Proposed Revisions to a Standard Plans Index

Originator:	Turley, Joshua	Index Number:	521-423
Date:	1/15/2025	Sheet Number(s):	2, 3
E-mail:	Joshua.Turley@dot.state.fl.us	Index Title:	Traffic Railing - (32" Vertical Shape)

SHEET 2 of 3

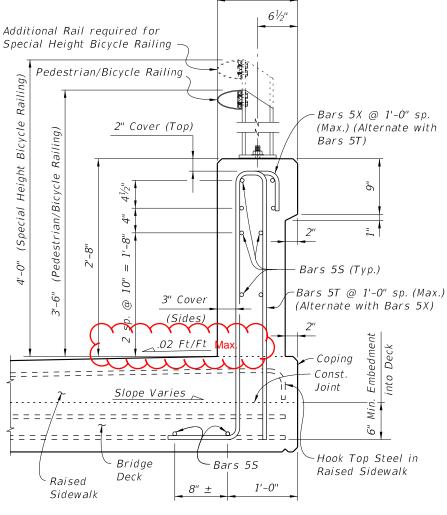
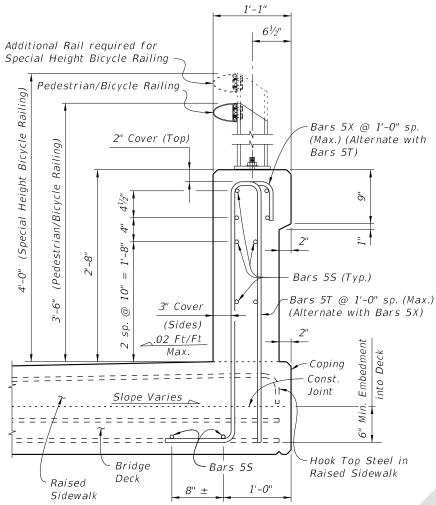
Sheet 2: Added "Max." to the slope.

Sheet 2: Some Districts and EORs have been using a sidewalk slope of 0.015 ft/ft to help make sure the finished slope stays within the ADA limit of 0.02 ft/ft. By adding "max" to the slope detail, the EOR has the flexibility to choose the slope. The intent is to hold the barrier height constant and thus the curb height along the roadway may be slightly taller (if the slope is less).

OPTION II (Alternative Mortar Plug at Open Joint)

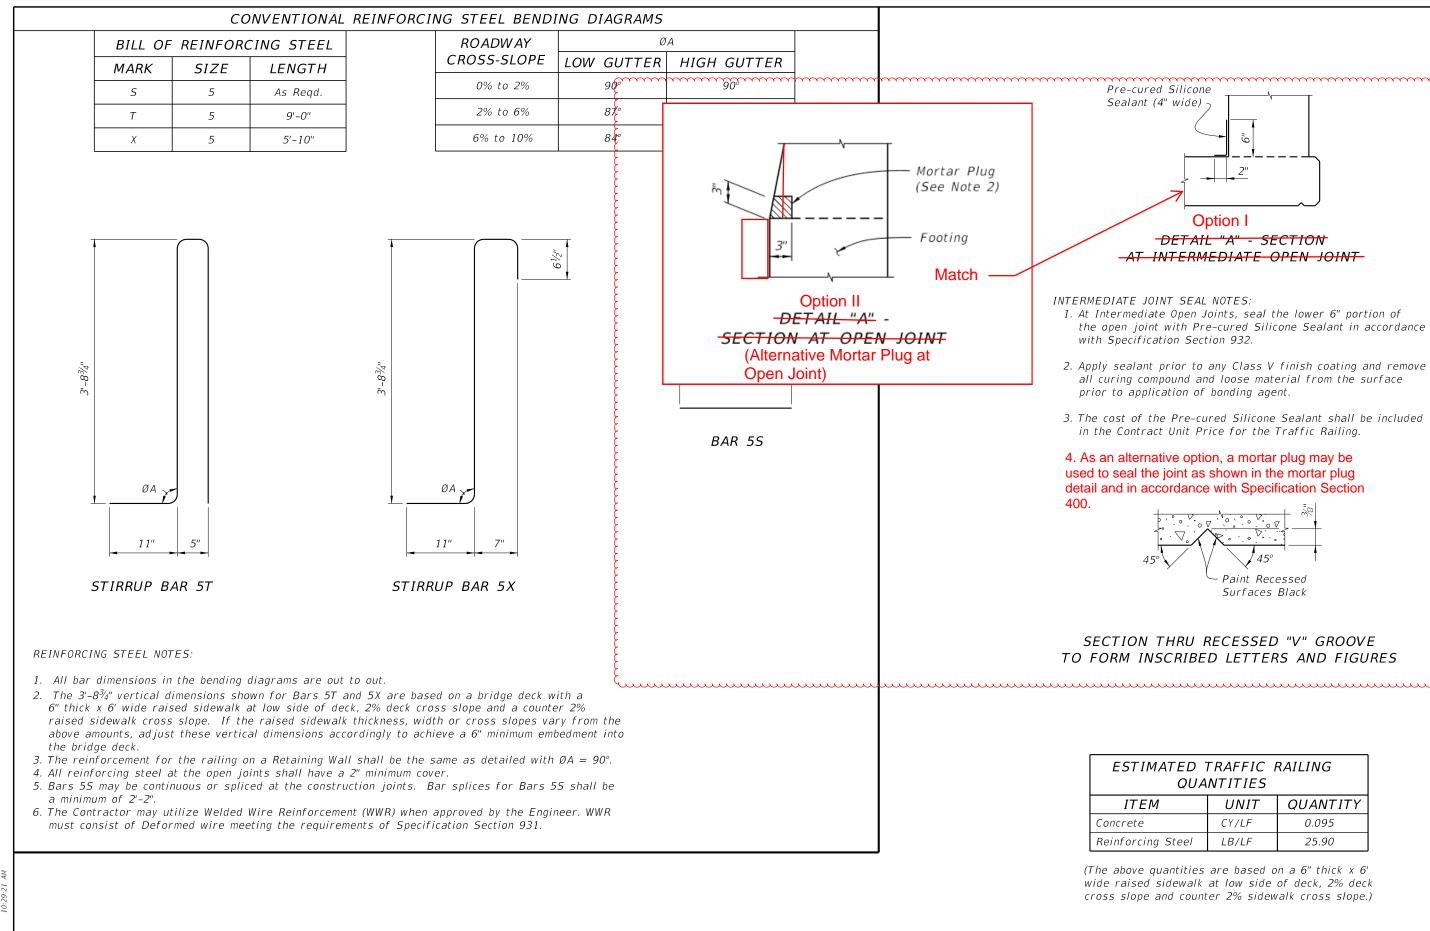
Sheet 3: Added a grout plug option as an alternate detail.

Sheet 3: Contractors requested a more constructible and economical option that would still perform the intended function of preventing water to flow out between the open joints.

- 1. At Intermediate Open Joints, seal the lower 6" portion of the open joint with Pre-cured Silicone Sealant in accordance with Specification Section 932.
- 2. Apply sealant prior to any Class V finish coating and remove all curing compound and loose material from the surface prior to application of bonding agent.
- 3. The cost of the Pre-cured Silicone Sealant shall be included in the Contract Unit Price for the Traffic Railing.
- 4. As an alternative option, a mortar plug may be used to seal the joint as shown in the mortar plug detail and in accordance with Specification Section 400.
